Access Compliance Report

(Curb Ramps)

Intersection ID: 16128	Main Street: HEMPSTEAD_PL	Cross Street: LOCKLEY_DR	Location: NE
ADA ID: 444CC36F477F	Ramp Type: PerpDiag	Initial Pass/Fail: Fail	Overall Compliance: No
Severity Score: 12.5			
Codes/Mitigation Info/Possible Solution		Field Measurements/Component Compliance

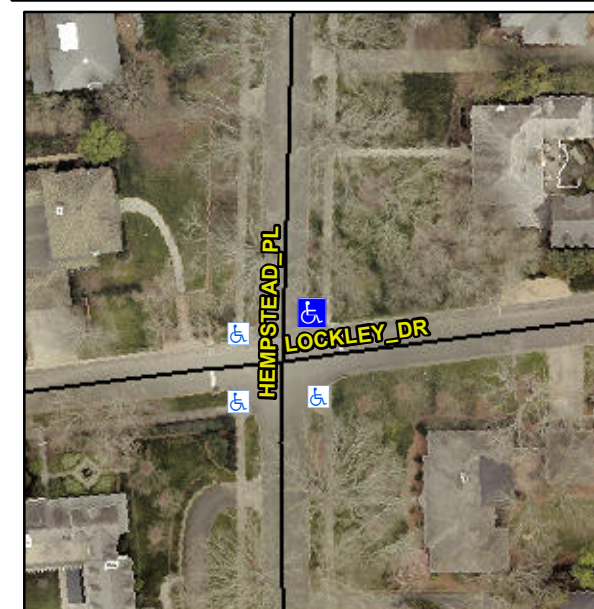
Not Found, R304.2.2

Compliance	Description	Data	Compliance	Description	Data
N/A	Ramp Length (in)	99.0	No	Ramp Slope (%)	10.4
Yes	Ramp Width (in)	48.0	Yes	Ramp XSlope (%)	1.0
N/A	Flare Type LT	N/A	N/A	Flare Type RT	N/A
N/A	Flare Slope LT (%)	N/A	N/A	Flare Slope RT (%)	N/A
N/A	Flare Traversable LT?	N/A	N/A	Flare Traversable RT?	N/A
N/A	Landing Length (in)	N/A	N/A	DWS Provided?	N/A
N/A	Landing Width (in)	N/A	N/A	DWS Contrast?	N/A
N/A	Landing Slope (%)	N/A	N/A	DWS Length (in)	N/A
N/A	Landing X Slope (%)	N/A	N/A	DWS Full Width?	N/A
N/A	Landing Curb? (Y/N)	N/A	N/A	DWS Offset (in)	N/A
N/A	Shared Landing?	N/A			
N/A	Gutter Ponding?	Yes	N/A	Gutter Slope (%)	N/A
N/A	Gutter Lip Ht (in)	N/A	N/A	Gutter X Slope (%)	N/A
N/A	Painted X Walk1?	No	N/A	Painted X Walk2?	No
	X Walk 1 Direction	To W		X Walk 2 Direction	To S
N/A	X Walk 1 Width (in)	N/A	N/A	X Walk 2 Width (in)	N/A
	X Walk 1 Slope (%)	3.2		X Walk 2 Slope (%)	1.2
	X Walk 1 X Slope (%)	0.9		X Walk 2 X Slope (%)	2.8

Remove & Replace Curb Ramp With Two New Directional Ramps or Equivalent.
